2019 State of the Platte

PLATTE RIVER
RECOVERY IMPLEMENTATION PROGRAM

Adaptive Management Plan (AMP)
2019 “Big Question” Assessments*
February 20, 2020

Prepared by the Executive Director’s Office of the
Platte River Recovery Implementation Program
4111 4th Avenue, Suite 6
Kearney, NE 68845

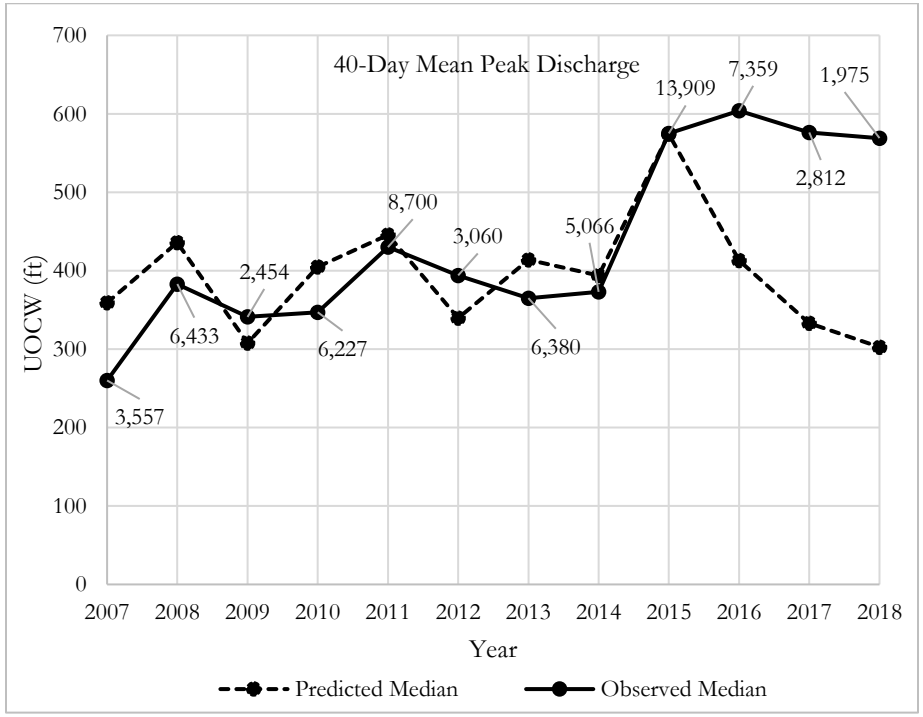
BQ2: Figure 3 shows a large departure between observed versus predicted median Unobstructed Channel Width (UOCW) in 2016-2018. This departure is explained by, *"there appears to be an additional driver (e.g., growing season flows, etc.) for maintaining channel widths once channels are wide."* **We recommend additional text briefly explaining how this departure may be addressed through the new 2-D modeling tool and other models presented during the AMP Reporting Session. Add text explaining how the new 2-D model can help to improve the ability to predict UOCW. The ISAC has suggestions for revising the structure of the decision tree model (see Section 2).**

EDO Response: Edits made in 2019 State of the Platte Report text.

"Due to the degraded model performance from 2016-2018, the EDO has started to utilize machine learning random forest models that better incorporate hydrologic metrics, physical channel characteristics, and management activities to predict the cumulative effects of these metrics on channel attributes over time. Two-dimensional (2-D) modeling will parallel statistical modeling, providing improved predictions of physical channel characteristics such as inundated channel area, velocity, and shear stress over a range of flow conditions. Taken together, these modeling approaches will provide a more robust basis for development and testing of flow-habitat hypotheses during the Extension" (BQ2 – 2019 Assessment).

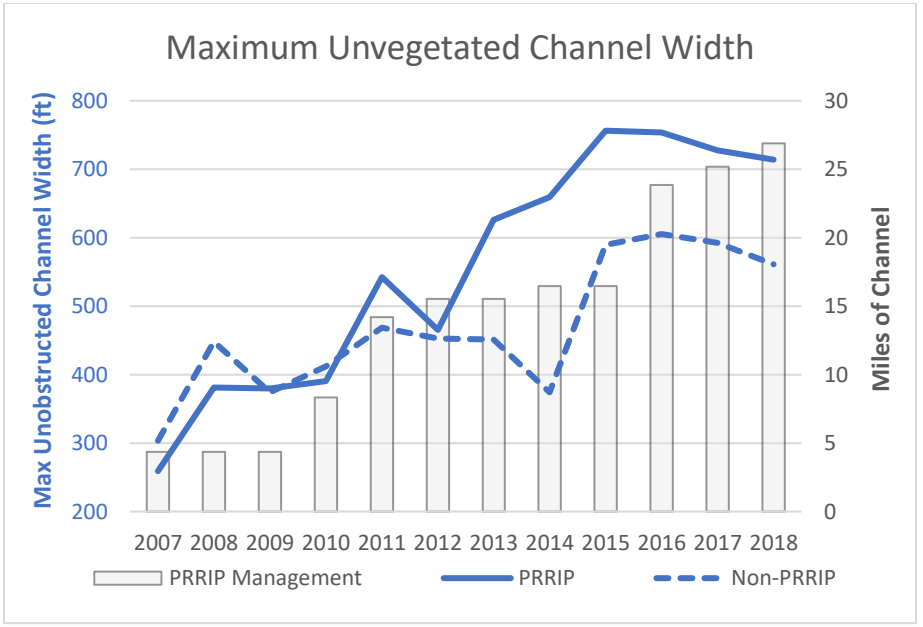
BQ10: The Draft 2019 On-Channel Whooping Crane habitat assessment needs to better explain the evidence for changes in BQ rating to two-thumbs up, given that results shown in Figure 10 have changed little in the intervening 2 years and hypothesis S1c remains*: "not yet answered - ongoing implementation, analysis and synthesis."*

EDO Response: Edits were made to the State of the Platte Report to indicate that an analysis of variance with post-hoc comparisons was used to compare distributions of annual maximum unobstructed channel width from 2007 – 2018 and indicated Program lands had significantly wider channel widths than non-Program lands since 2013. Pearson's Rank Correlation showed a statistically significant increase in whooping crane use on Program Lands since 2016.
